SLCWI Hydrological Modeling Project
Draft Report Comments
Responses in blue/italics

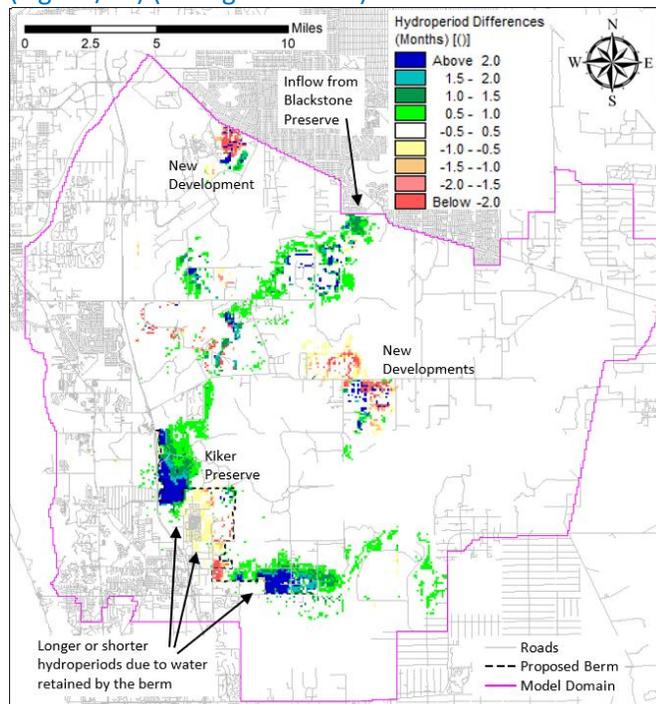
1. Make sure all acronyms are defined the first time they appear anywhere in the report including LiDAR and DEM
 - *Addressed: All acronyms have been defined at first mention in the text. Those acronyms mean:*
 - i. *LiDAR: Light Detection and Ranging (pg. 13 v.1)*
 - ii. *DEM: Digital Elevation Model (pg. 12 v.1)*
2. Maps lack references like roads, preserves, etc., so are hard to read.
 - *Addressed: A roads shape file has been added to the figures that show scenario results. (Fig. 10/11) (Ex: Fig. 10 below)*

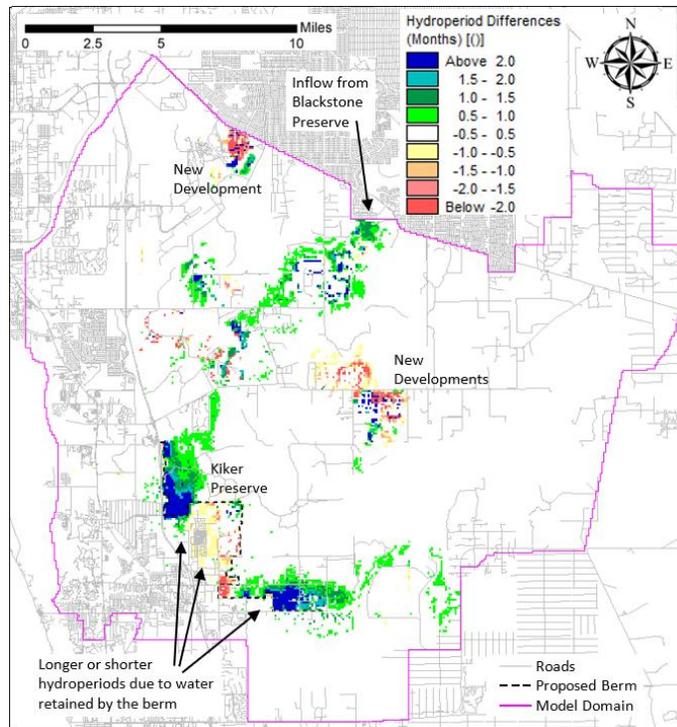
- **1.3.11: East I-75 Overland Flow Collection Drainageway.** *The proposed conceptual project 1.3.11 connects existing borrow pit lakes (also referred to here as ponds) east of I-75 to the conveyance structures under I-75. The project consists of creating a collector drainageway that would direct overland flow and equalize water levels at each I-75 crossing to fully utilize each structure. Control structures with overflow elevations ranging from 18 to 19 ft-NAVD would be installed in the berm.*

- **1.3.13 CREW-Flint Pen Strand Hydrological Restoration.** *The proposed conceptual project 1.3.13 would develop a water storage area located within the boundaries of Kiker Preserve, Flint Pen Strand, and the Southern Corkscrew Regional Ecosystem Watershed (Southern CREW). The project objective is to hold excess stormwater upstream of the proposed berm until downstream developed areas have drained following a large storm event. This area would be contained within a perimeter berm and will have remotely operated control outflow gated structures to maintain the water level within desirable ranges. The berm configuration used in this modeling effort was obtained from a second berm alignment proposed as part of additional flood mitigation studies conducted for Lee County and was the latest information available at the time of the scenario analysis.*

- *Addressed: Brief definitions are in the final report and a reference was added to Appendix J: (pg. 18 v.1) The Existing Conditions (ECwP) Model included urban developments that have been permitted and have started construction, as well as some of the high-priority projects from the Lee County’s Flood Mitigation Plan. Lower-priority projects from the Lee County Flood Mitigation Plan were not included because implementation for the lower priority projects is uncertain. The high-priority Flood Mitigation Plan projects included in the ECwP model are summarized below:*

- **1.3.4: Alico Mine Lake Interconnects (West).** *This proposed conceptual project consists of connection of an existing stormwater pond on the Southwest Florida International Airport to a number of mining pits north and south of Alico Road. This proposed conceptual project is intended to reduce flooding by capturing stormwater in the pond and mining pits.*

- **1.3.7: Blackstone Drive to Alico Mine Lakes Drainageway.** *The proposed conceptual project 1.3.7 conveys excess stormwater drainage flow from Blackstone Drive area in Lehigh Acres lying south of SR 82 to the existing Alico Mine Lakes. The originally proposed project is conceived with a control structure that would allow gravity-driven flows. There is not always a positive hydraulic gradient for the surface water to flow south, so for this study, the original proposed structure has been replaced by a 10-cfs pump as a refinement modification to the proposed project.*

- **1.3.8: Alico Mine Lake to Halfway Creek Drainageway.** *The proposed conceptual project 1.3.8 utilizes the existing mine lakes in the WildBlue development currently under construction lying north of Corkscrew Road for storage, conveys water into the Flint Pen Strand preservation area, and directs excess flow towards the Halfway Creek bridge under the I-75. The replacement of some culverts under Corkscrew Roads is proposed as part of this project.*

Figure 9 illustrates the location of the projects listed above. Note that the proposed projects listed above were modified to reflect recent development. In addition, some hydraulic structures were modified, removed, or added in this study to maintain and/or enhance hydrologic restoration of natural areas, including wetlands, while not diminishing the level of added flood protection. Finally, two other future projects (namely the new Corkscrew Crossing conveyance and hydroperiod restoration at the south end of Corkscrew Swamp Sanctuary) were added in the ECwP model.

Selected graphs were generated for five years of the simulation (period truncated so that differences between scenarios are easier to understand) and are shown below:

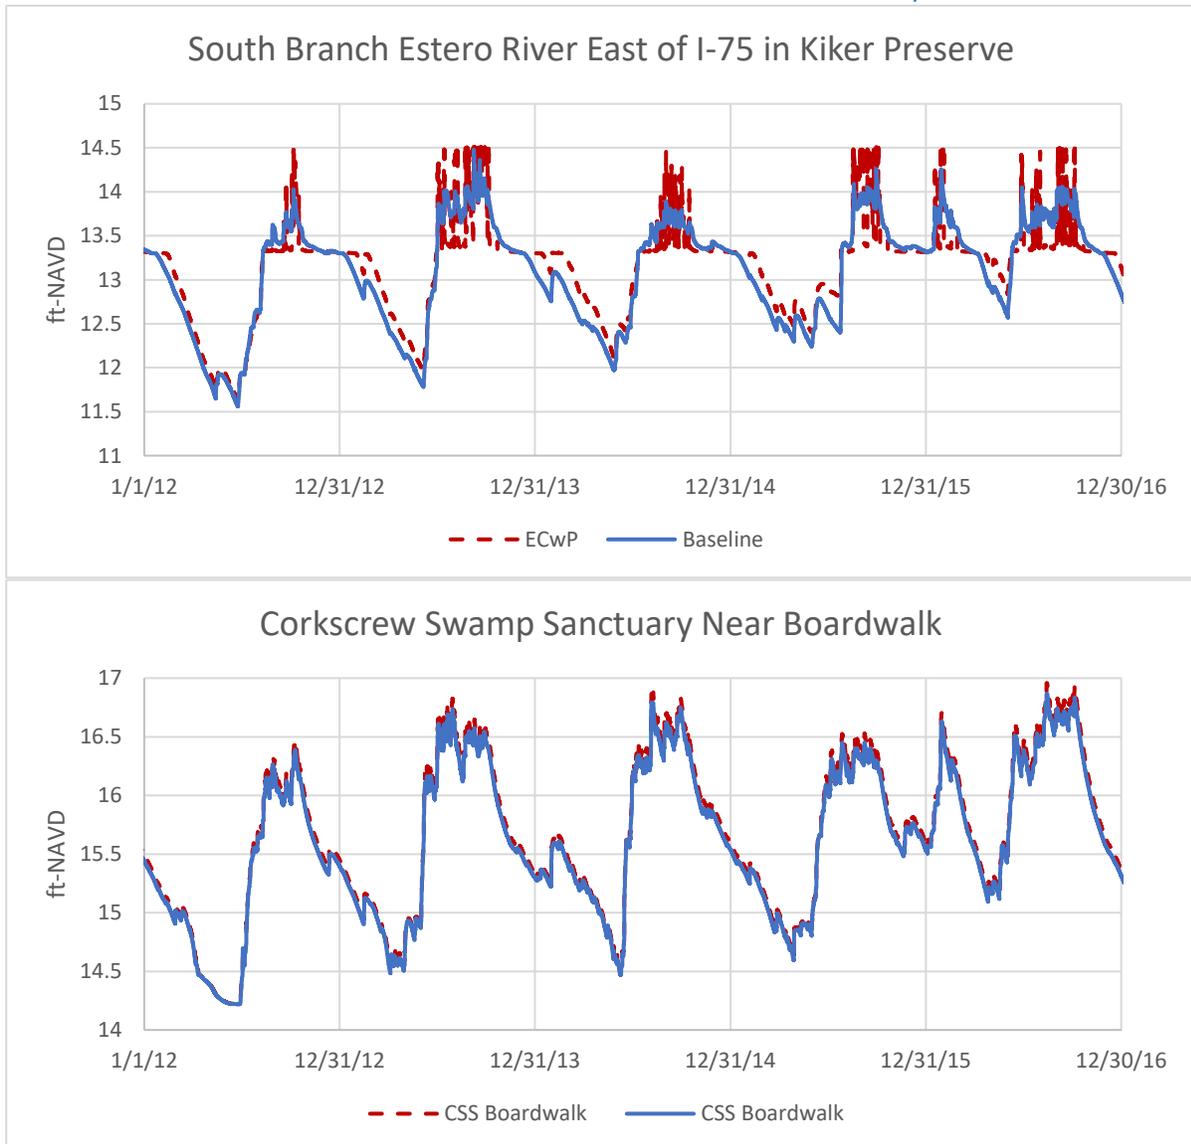
24. Is there a way to see some hydrographs that would show the relative draw-downs during the peak of the dry season with the different scenarios that were run? There is a worry about the idea of fires in these natural area systems later in the dry season. Extending the hydroperiod can be very helpful, but it still would be very useful to know how low the water table goes during the dry season in the different scenarios.
- *Addressed: The following text was added to Recommendations Section (pg. 27 v.1): Where existing natural areas have wetland hydroperiods less than optimum, green*

- Addressed: Throughout CREW (and other inland marshes and prairies), reducing hydroperiod can encourage the spread of Carolina willow which may increase evapotranspiration even further. Hydroperiod reductions throughout CREW will have significant impacts on fire (both land managers' ability to conduct prescribed fire and risk of catastrophic wildfire). These changes in vegetation/land cover and their potential impacts (including exacerbating hydroperiod reduction), as well as the uncertainty of rainfall overall, emphasizes the need for hydrological preservation and restoration.
- Addressed: (Fig. 10-14) Maps included the difference in water table levels at the peak and the end of the dry season. This helps to explain if the water levels will be lower or higher at the end of the dry season as a result of the projects and/or climate change.
